Submissions Report

SUNRAYSIA SOLAR FARM, BALRANALD

Sunraysia Solar Farm Submissions Report

Figure 1: Sunraysia Solar Farm Proposal – Exploration Licence (EL) 7626

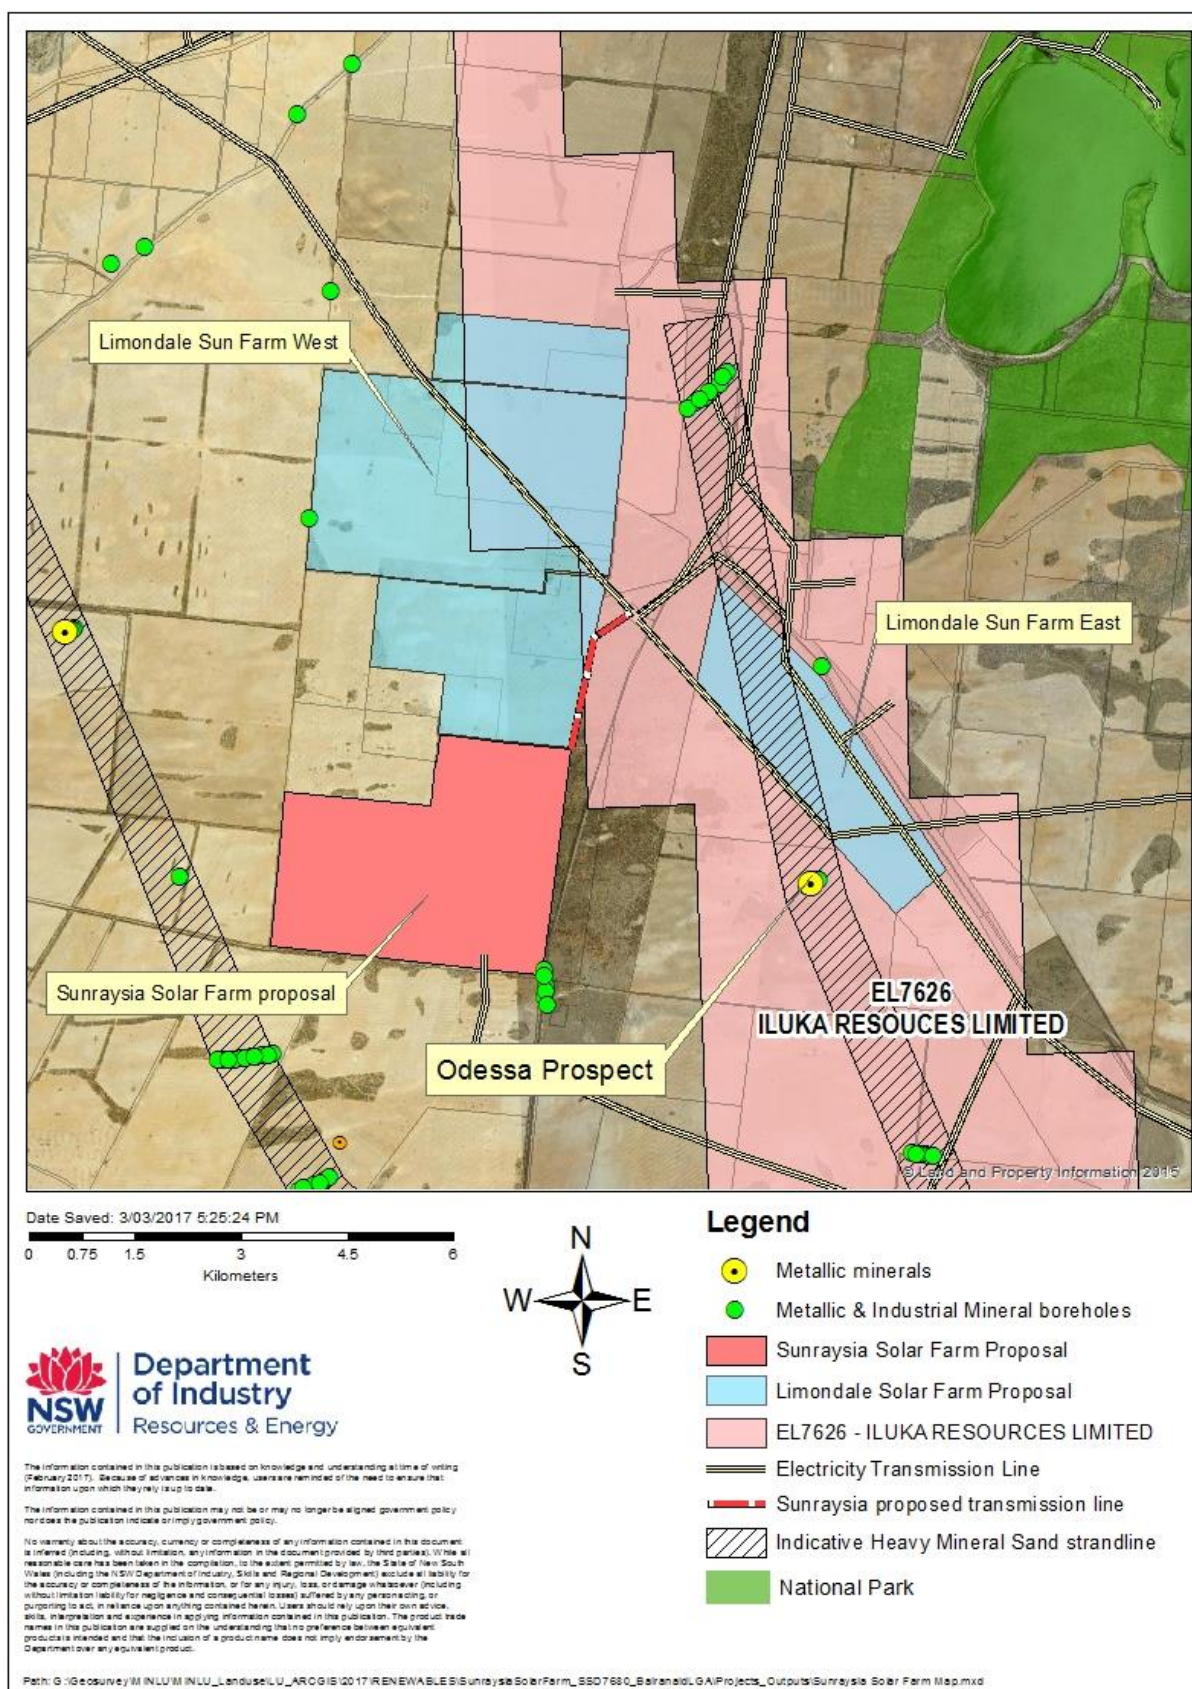
The area of EL7626 was reduced upon submittal of the application for renewal on 11th October 2016 in compliance with the requirements for reduction of tenure area under the Mining Act 1992. The title will remain in force until a determination has been made by the decision maker regarding the renewal application. The licence EL7626 now only covers the Odessa deposit and does not overlap with the Sunraysia proposal. However, the location of the proposed power transmission corridor does transect EL7626 and the Odessa deposit (Figure 1).
